October 1, 2024

Re: 3rd Stormwater Peer Review
Amendment for 140 Haverhill Street
Andover, MA
MassDEP File No. 090-1383

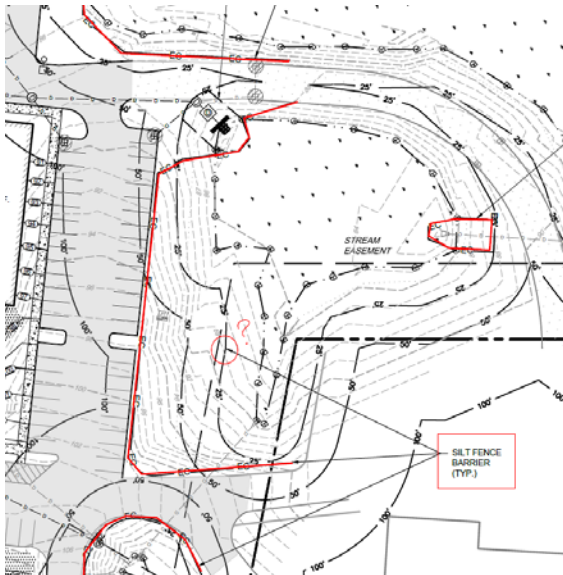
- b. It appears that the existing driveway on the north side of the parcel will be removed in accordance with the Demolition Plan. It is not obvious if this driveway will be repaved or replaced with loam and seed. HW recommends that the Applicant clarify the proposed plans for the northern driveway. If the driveway is removed credit for the reduction of impervious surfaces can be accounted for.

September 16, 2024: The Applicant has stated that the area where the parking lot pavement is being removed is replaced with topsoil. HW was questioning the access driveway on the north side of the site. The Demolition Plan calls out to remove the pavement and curb for this driveway as highlighted in red in the image below. No further direction was obvious in the plan set. HW recommends that the Applicant clarify the proposed plans for the northern driveway.

October 1, 2024: The Applicant has clarified the confusion. The existing asphalt shown in red below will remain. The area hatched is to be removed. No further action requested.
